CODES AND STANDARDS ENHANCEMENT INITIATIVE (CASE)

Statewide Utility CASE Team Responses to Additional Stakeholder Comment Letters on the Proposed Title 24 Standards for Residential Lighting

Measure Number: 2016-RES-LTG1

March 26, 2015

Figure 3: Low risk and no observable effect regions for flicker (Lehman et .a 2014) overlaid with region of graph not compliant with "reduced flicker operation" requirement

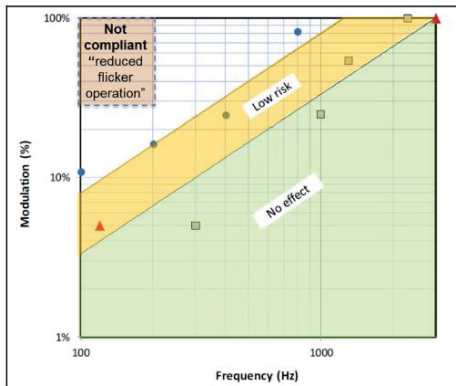
The flicker thresholds proposed have not been technically justified and do not accurately represent the flicker potential of the light source, luminaire and dimmer operating as a system. The proposed standard focuses on flicker percent rather than flicker index, which is the most common approach to quantifying flicker. The proposed restriction on flicker percent will eliminate some energy efficient and cost effective step drivers for residential applications. There is a series of ongoing research in the area of flicker. It is premature, and potentially harmful, for the Commission to establish arbitrary levels at this time. We refer the Commission to our recent comments to Title 20's rulemaking regarding Flicker.³ While NEMA agrees that flicker test procedures are needed, and our members are actively participating in these efforts internally and externally to the association, we disagree with CEC's attempts to be the source of these test procedures. There are several efforts underway in groups such as IEEE 1789 (document in ballot), IEC, NEMA (SSL-7B) and at research facilities such as LRC (ASSIST program) and others. CEC should defer to the scientific lighting community on this subject and not undermine their efforts with a one-off State-specific requirement which has not been adequately tested. We again refer to our comments to CEC Title 20 on the issues regarding the inadequacy of the Flicker Test proposal development process.

The draft language in Section JA10.2 is confusing and should be withdrawn. For example, it is unclear which dimmer(s) are to be used. As written the test arguably must be repeated for every dimmer/lamp combination, and every number of lamps that can be used, and the test results reported and enforced by CEC. The uncertainty and administrative burden should not be overlooked. Our point is that there is a huge amount of testing required to confirm compatibility using the proposed California-specific approach. This testing will rapidly become burdensome, and will never ensure 100% compatibility.

Title 24 has had the same requirements for “low flicker operation” of dimming controls since the 2008 Standards. This requirement pertains to dimming sources controlled by dimming controls that have less than 30% amplitude modulation for frequencies less than 200 Hz. The metric used (amplitude modulation or percent flicker) is a commonly used metric in the lighting industry and is officially defined in the IES handbook. Despite the adoption of this 2008 standard, other groups have not stepped forward and developed a test method. Further, California has been publically working on this flicker test procedure since Spring of 2014; NEMA has been aware of this effort but has not provided any data on how light sources perform in terms of flicker, how their products perform using the proposed test method, nor has NEMA proposed improvements to the test procedure. The CASE Team has developed the proposed test method based on work conducted by Pacific Northwest National Laboratory and made use of analytic methodology described by Brad Lehman at Northeastern University (who is also the chairman of the IEEE PAR 1789 committee). The CASE Team has also been in touch with the ENERGY STAR program as they have been drafting their draft criteria for the ENERGY STAR Luminaires Version 2 specification. ENERGY STAR is considering a reporting methodology that would harmonize well with the requirements in JA10.

NEMA refers to the IEEE PAR 1789 committee which is working on a flicker standard. As described in the Residential Lighting CASE Report, the proposed requirement is less stringent than the proposed flicker guideline being developed in IEEE PAR 1789. Figure 3 from the CASE Report is included below.² Though the California “low flicker operation” requirement is less stringent than setting a standard at what is considered to be non-high risk, we believe that once flicker is quantified and published in a CEC flicker database that manufacturers will voluntarily design to even lower amounts of flicker. Thus, the proposal does not require more stringent flicker requirements than what have been in place since 2008. However, the proposal does recognize that flicker is not just a function of the control but also of the light source and its driver or ballast.
